**PREPARED TESTIMONY OF RICHARD KUPREWICZ
EVALUATING PG&E'S PIPELINE SAFETY ENHANCEMENT
PLAN**

**CALIFORNIA PUBLIC UTILITIES COMMISSION
PIPELINE SAFETY RULEMAKING
R. 11-02-019**

**Submitted on behalf of
THE UTILITY REFORM NETWORK (TURN)**

January 31, 2012

Figure 1: Number of Miles Scheduled for Strength Testing by PG&E's Decision Step Output

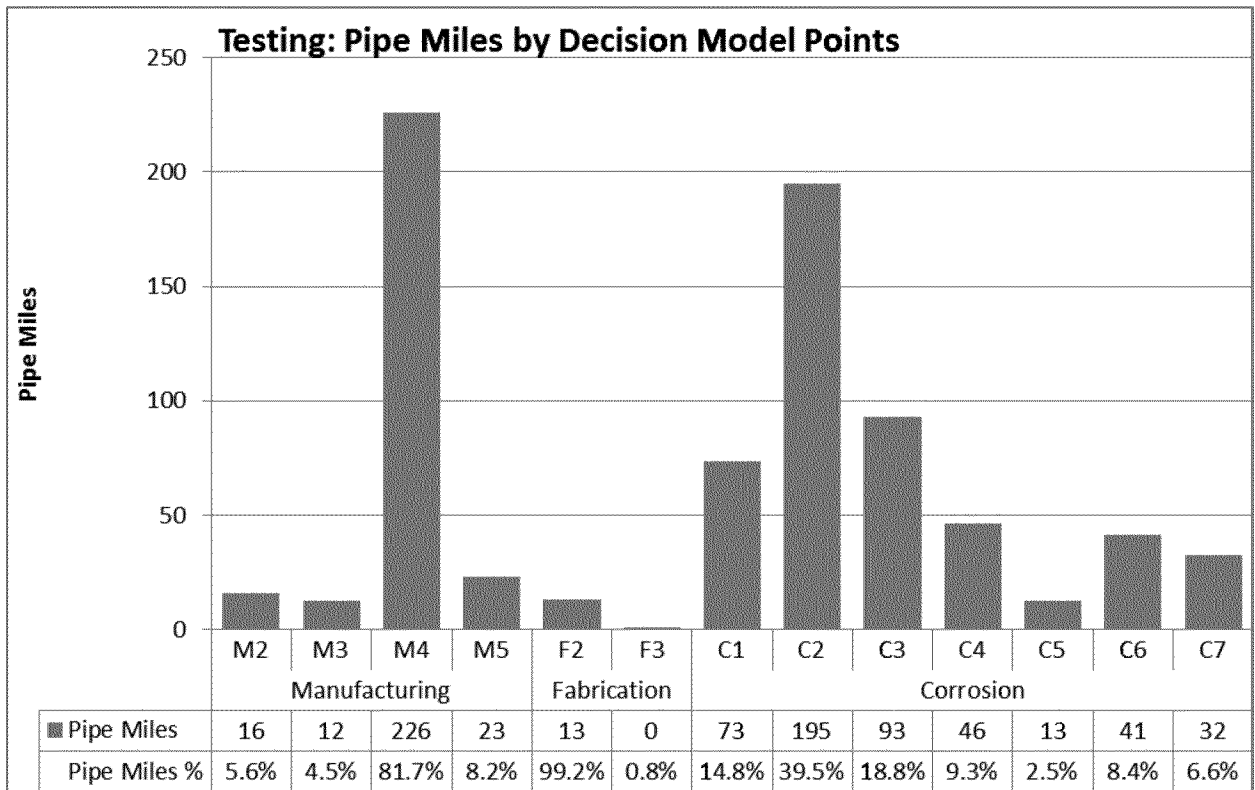
- Corrosions Threats: The Decision Tree needs to be revised. For the 493 miles PG&E is proposing to be scheduled for testing due to the corrosion decision tree (see Figure 1), I recommend that ILI is a better assessment tool if the pipe can be retrofit for piggability. Prudent leak survey analysis, however, will be a better assessment approach for the lower stress (< 30 SMYS) segments where corrosion/third party damage is the only threat of concern. I do not recommend relying on any of PG&E's past integrity management outcomes.

Figure 2: Number of Miles Scheduled for Replacement by PG&E's Decision Step Output

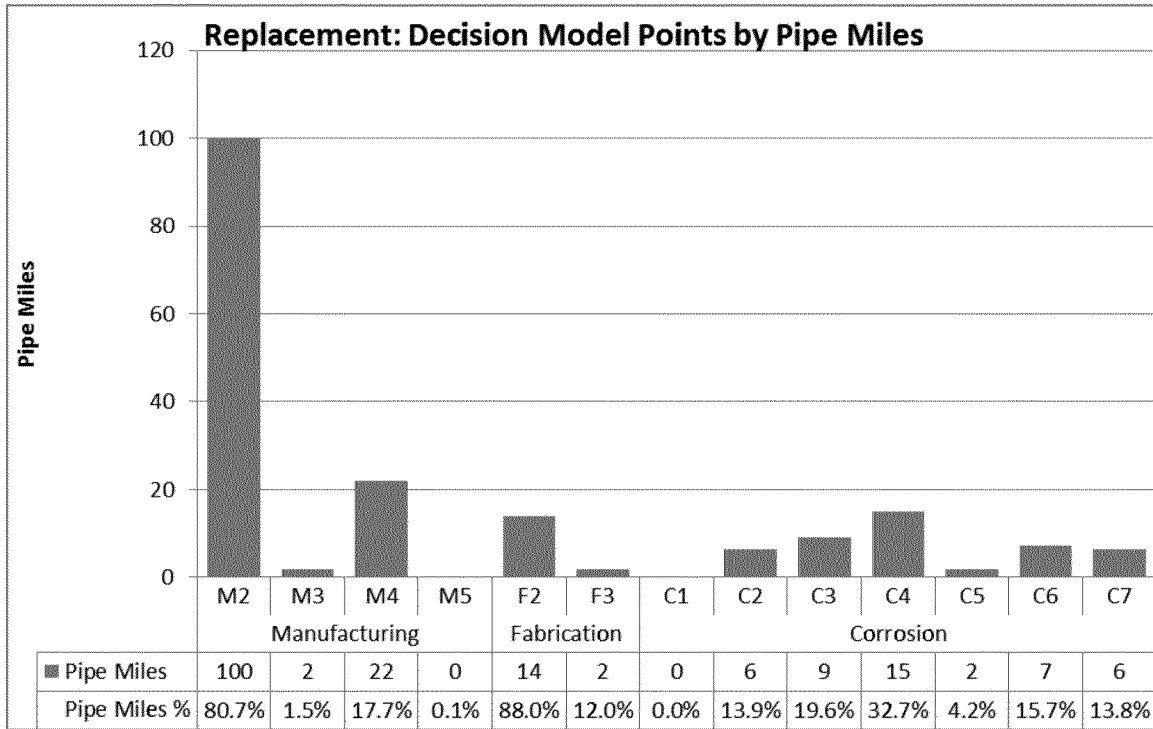
The PG&E Proposed Decision Tree process appears to result in an unusually high and disproportionate number of miles for pipe replacement. The decisions to replace need a

For example, over 100 miles of replacement result from PG&E's Decision Tree Step M2. Step M2 results in a decision to replace large diameter (during Phase 1) Urban pipe with manufacturing threats that operate at >30% SMYS. Step M2 should be modified to say, "Reduce Pressure & either Strength Test or Replace in Phase 1." If the line can survive a prudent hydrotest the extreme of replacement for seam weld threats needs to be specifically justified. Before proceeding to a replacement decision other steps should be added asking or indicating what critical factor(s) drive to replacement over hydrotesting or ILI? For example does the pipeline segment contain at -risk manufacturing seam factors that hydrotesting or ILI cannot adequately assess? And more importantly is there a problem with the pipeline segment that has led PG&E to determine that a specific pipe segment would experience numerous hydrotest failures that would justify pipe replacement? Could the pipeline be rationally shutdown for hydrotesting or ILI conversion? (if not, then pipe replacement may be warranted).

TURN believes the majority of pipeline meeting step M2 should be able to be hydrotested. Step M2 in PG&E's plan results in 100 miles of pipe replacement. I estimate that a very high percentage of this pipe, on the order of 95 +%, or 95 plus miles, would pass a prudent hydrotest and should not be replaced.

Figure 3: TURN’s Proposed Flow Diagram Replacing Steps 2F, 2G, F2 & F3 in PG&E Pipeline Modernization Decision Tree

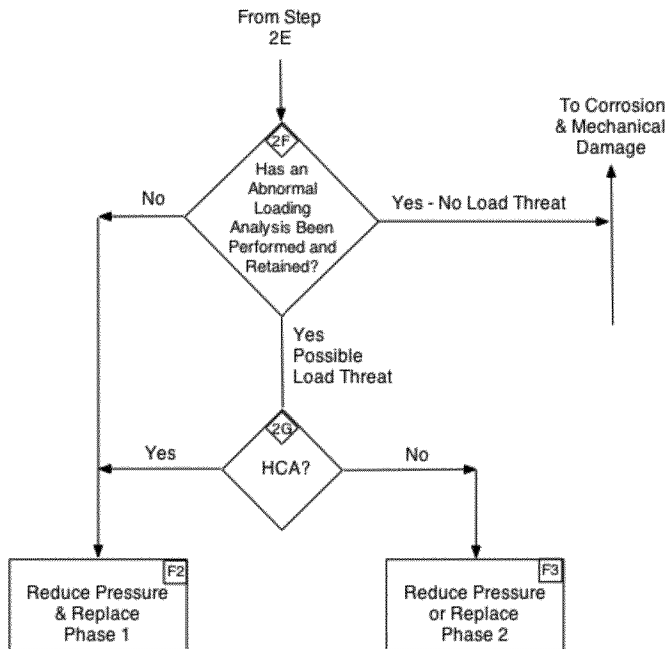
The Engineering Condition Assessment ("ECA") proposed in Decision Tree Step 2C is not adequately explained, and thus we cannot evaluate whether PG&E's planned work is sufficient to address fabrication or construction threats. PG&E's response to TURN was

that “PG&E does not have an Engineering Condition Assessment (ECA) procedure in place for the Pipeline Safety Enhancement Program, but is working to develop an acceptance criterion to assess the condition of the Decision Tree referenced antiquated or abnormal pipe joints, girth welds, angle points, or other fittings.”²² There is too much left to the discretion of the operator to ensure that this threat category will be adequately addressed or resolved if the operator is left to make this important decision on their own. Citing industry standards or the explanation that PG&E is planning to work with experts without providing sufficient detail to permit an independent review is an unsatisfactory response. More specifically, ASME B31.8S -2004 which is specifically referenced in federal pipeline safety integrity management regulations, only permits ECA in “some defects,” related to third party damage, manufacturing and construction welding, not in most of the situations defined in step 2B.²³

TURN proposes that steps 2F, 2G, F2 and F3 be replaced as indicated in Figure 3. This alternate decision tree introduces another step to determine whether an “abnormal loading analysis” has been performed. Segments where the abnormal loading analysis has shown that there are no load threats can pass the Fabrication and Construction Threats tree, but should be added to a list of segments that PG&E should periodically monitor in their right-of-way program to assure the abnormal loading threat conditions haven’t changed.

Figure 4: TURN's Proposed Decision Tree for Corrosion and Mechanical Latent Damage

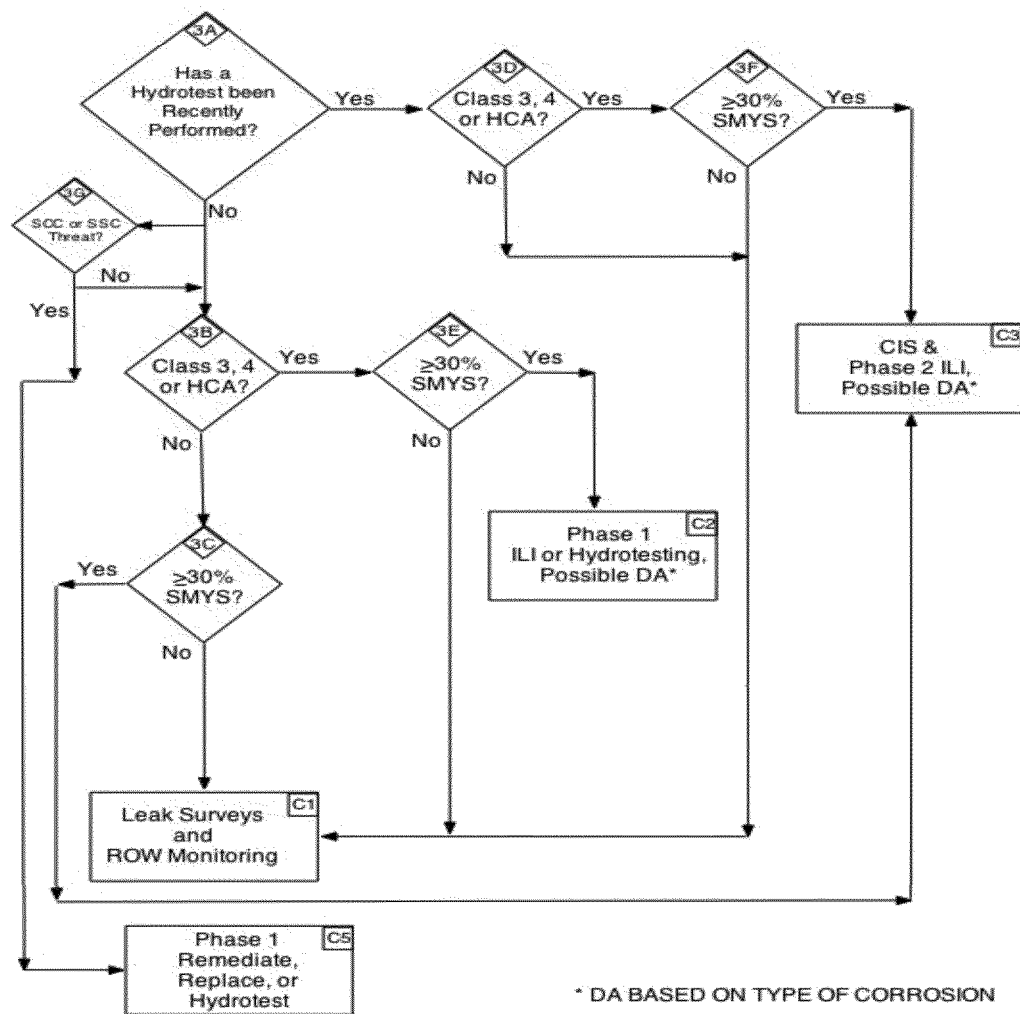
Given the nature of this threat family to cause time dependent pipeline failure (either leak or rupture), a previous Subpart J strength test, especially performed some years in the past, has little benefit in filtering out these risks of failure because a prudent hydrotest's intent is to take an existing at-risk anomaly to failure. PG&E's proposed Step 3A is thus incorrectly framed, as a hydrotest will not identify corrosion or mechanical damage threats introduced after the hydrotest. In addition, given the problems associated with PG&E's incomplete and inadequate integrity management program, we place little credit in its past program to address even the threats identified as "Corrosion & Latent Mechanical Damage Threats," and as a result TURN recommends not incorporating the BIAP step (step 3D) in PG&E's Decision Tree which is highly and overly dependent on DA (see Table 10).

In attachment 4, TURN has removed the Decision Tree Step 3D, as the reliance on improper and incomplete DA approaches or misapplication of DA in the past integrity management program, gives us little confidence that PG&E's BIAP has or is adequately addressing this threat category, even for corrosion threats. TURN proposes to change step 3D to a class 3 & 4 or HCA decision as shown in our revised decision tree.

Figure 4 is TURN's proposed flow diagram for this threat category that we believe is more appropriate and that should replace PG&E's PM Decision Tree for pipeline segments containing only this family of threats. Comparing Figure 4 to PG&E's Attachment 3A illustrates another problem when approaching pipeline threats utilizing a sequential flow diagram method. The conclusion may not make sense (such as suggesting hydrotesting or ILI for transmission pipelines that are much more likely to leak, rather than rupture), or might miss important threat considerations, such as Stress Corrosion Cracking, ("SCC"), or selective seam corrosion, ("SSC"), specialized forms of selective corrosion that usually

Figure 4. TURN is basically recommending for non urban areas, as well as urban areas both operating at < 30% SMYS step C1, that efforts be focused on leak monitoring/evaluation and prudent right-of way monitoring, unless these segments can cost effectively be converted to ILI over time.

Figure 5: Blowdown Time, reproduced from PG&E Figure 4-7

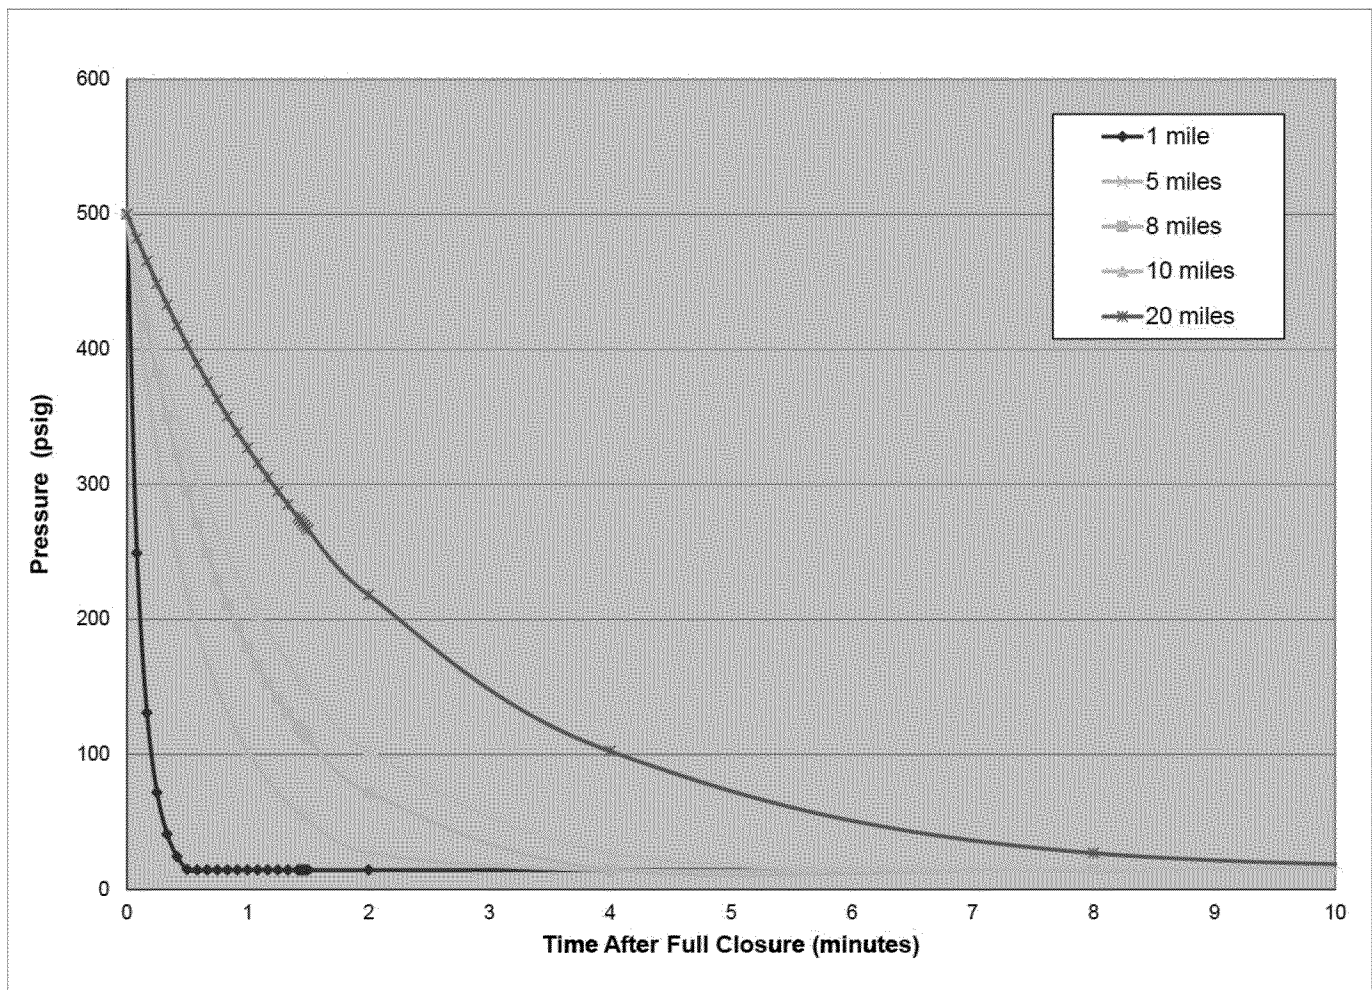
Figure 5 reproduces Figure 4-7 from PG&E'S Testimony. This figure is incomplete, as it is missing critical information, such as pipe diameter, and seriously understates the isolation blowdown release times for gas transmission pipelines following rupture. The figure attempts to identify blowdown times but fails to accurately portray such times for gas transmission pipeline ruptures.

PG&E apparently developed this figure for one particular pipeline diameter - a 12-inch pipe - and the calculation method used by PG&E's experts is unsuitable for long transmission pipelines.⁵¹ The approach used by PG&E to estimate blowdown times for gas transmission pipelines ruptures to develop PG&E's Figure 4-7 is very inappropriate and should not be utilized for valve decisions on long gas transmission pipelines as pipe length, diameter, and friction factor play a substantial role in estimating rupture release impacts with time.

Figure 7- Isolation Blowdown Time for Gas Transmission Pipeline Ruptures as a Function of Valve Distance from Rupture and Pipe Diameter

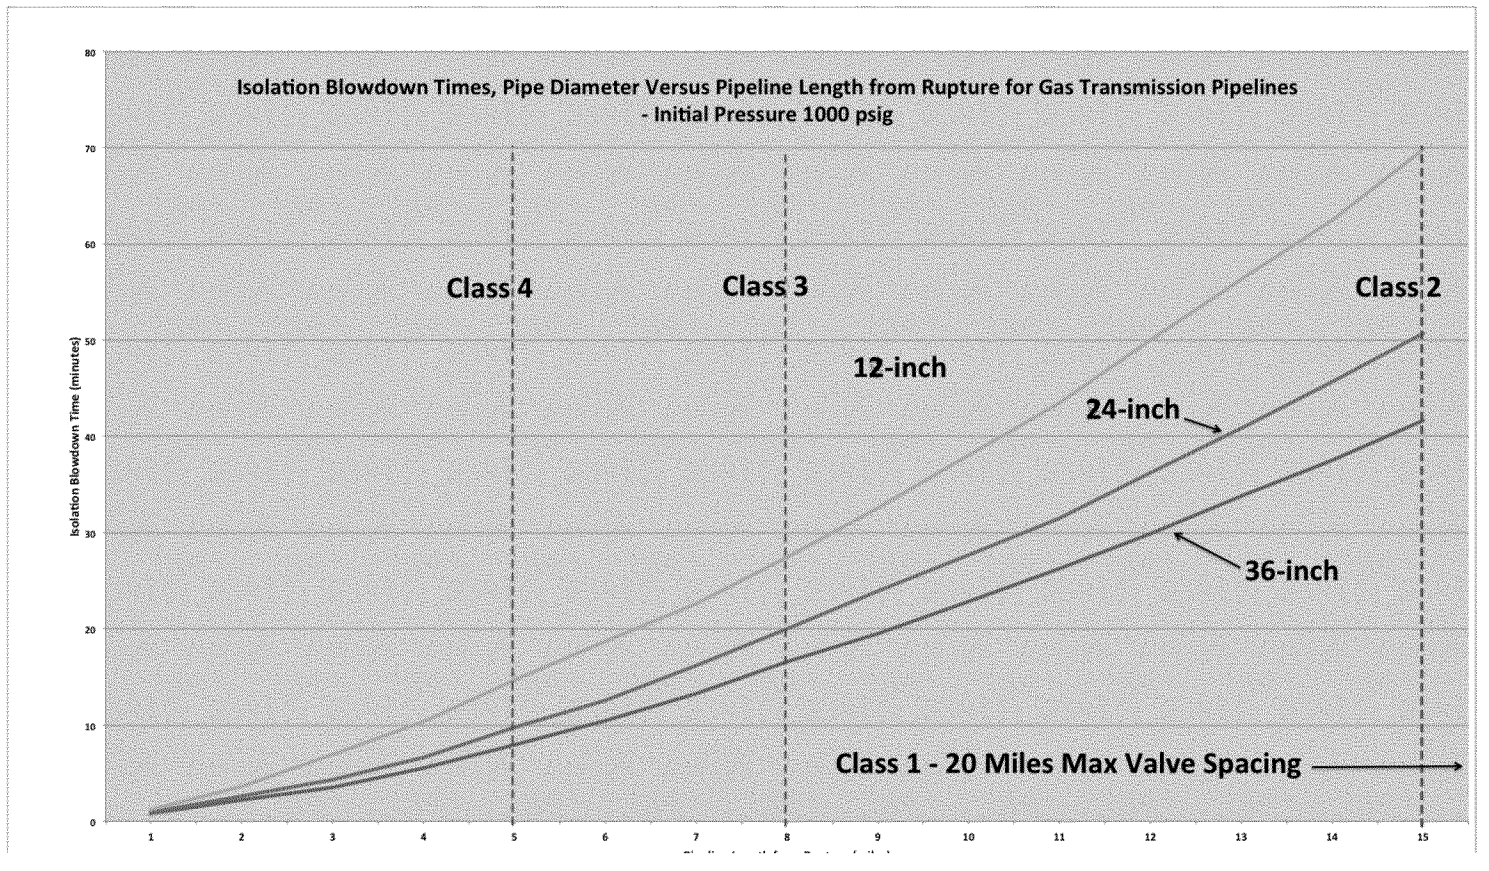
Figure 7 contradicts PG&E's testimony that "A full line break with eight mile spacing with a pipeline starting pressure of 1000 psig is estimated to blowdown in five minutes."⁵⁶ Figure 7 indicates blowdown times significantly greater than five minutes, regardless of the pipe diameter. PG&E needs to explain this serious discrepancy, and provide an appropriate engineering analysis representing transient compressible flow in transmission pipelines that can be independently publically reviewed and confirmed.

Figure 7 also indicates that for an 18-inch pipeline with a 7.2 valve spacing (see Figure 6), blowdown times for calculated vs actually measured time are comparable correcting for the higher initial pressure of 1000 vs 500 psig.

Figure 6 and Figure 7 indicate that valve spacing plays a much greater role in isolation blowdown times than indicated by PG&E's testimony. Isolation blowdown times clearly impact decisions related to valve spacing and valve automation.

Figure 9: PG&E Valve Decision Tree

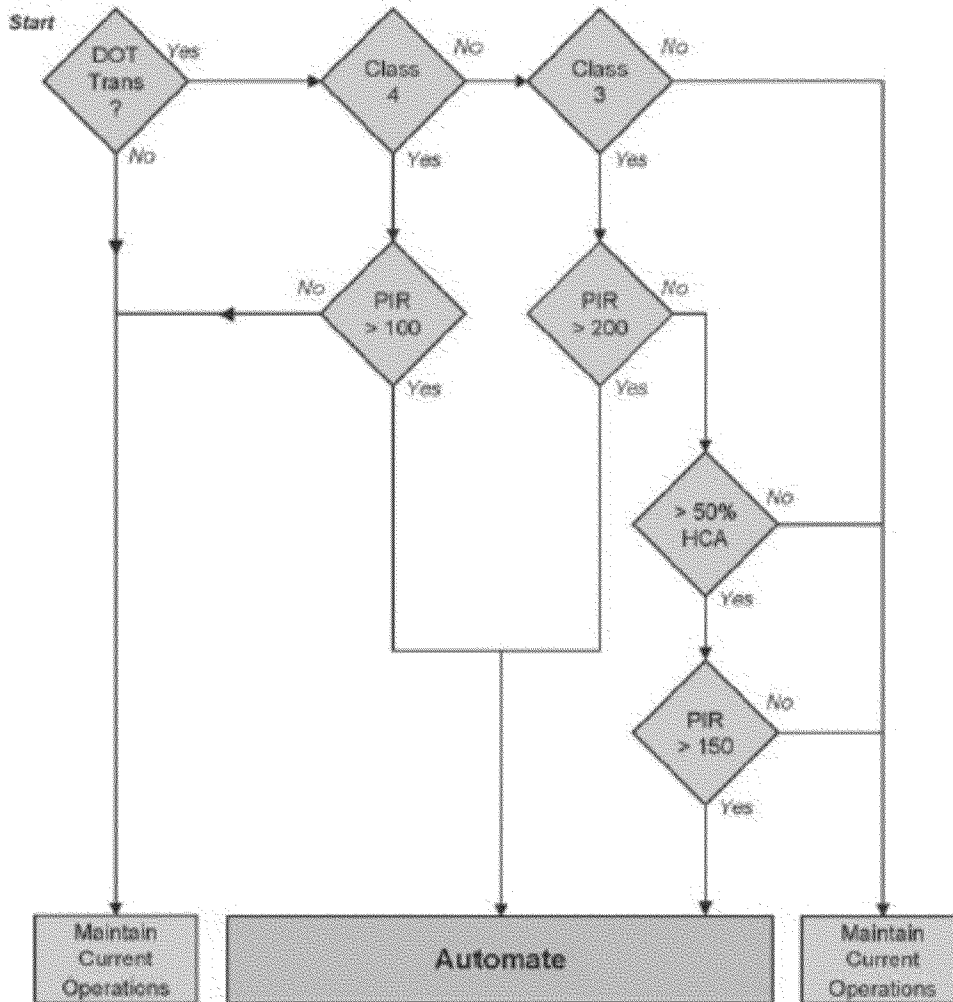
PG&E’s decision trees, which are reproduced as Figure 9 and Figure 10 below, are inadequate.⁶⁴ PG&E’S use of the PIR in their valve decision trees does not adequately address the goal of quickly reducing high heat flux times and actual impact zones.

Figure 11 is a more appropriate valve decision tree that TURN recommends should be utilized to determine the prudent placement and automation of valves on gas transmission pipelines. Several important points related to Figure 11 need to be highlighted.

Figure 12– PG&E’s Proposed Phase 1 Valves by Pipe Diameter and Pipe Miles in Class 3 and 4 and 4

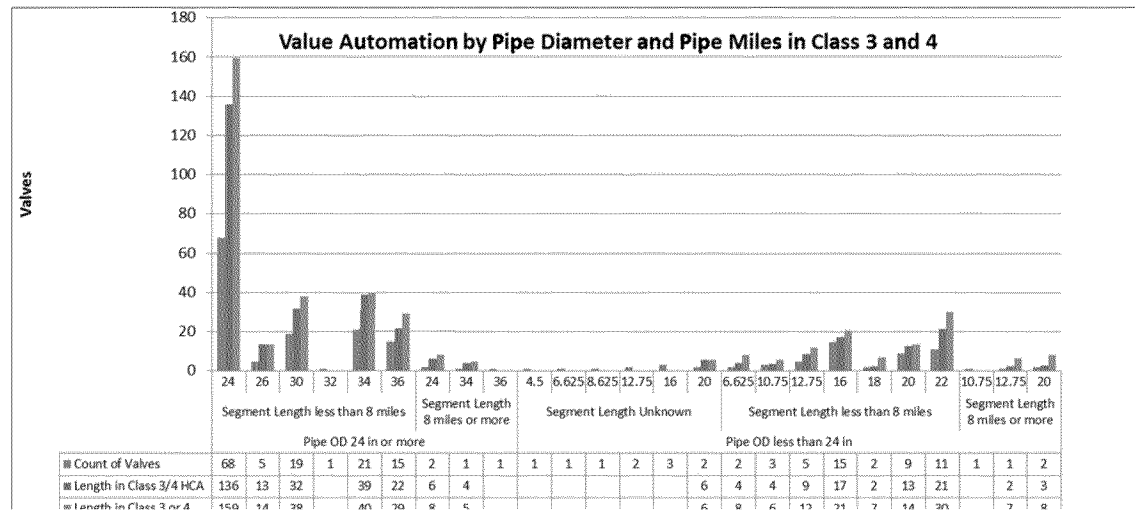
In addition Figure 12 provides a more detailed analysis of the PG&E proposed 194 valves in their proposed Phase 1. Figure 12 indicates that 61, or approximately one-third of PG&E's proposed valves, would be on lines less than 24 inch in diameter.⁶⁶

Figure 12 also indicates that four of the Phase 1 proposed valves on the larger diameter pipelines have valve spacing greater than 8 miles. TURN believes a closer study of the specific location of these four valves is warranted, though the isolation blowdown may not change significantly. A review of Figure 7 indicates that isolation blowdown times for smaller diameter lines will prevent even ASVs from meeting the 30 minute responder goal for valve spacing of eight miles. Fortunately, smaller diameter pipelines produce much smaller potential impact zones following a rupture than their larger diameter counterparts during longer duration burns.
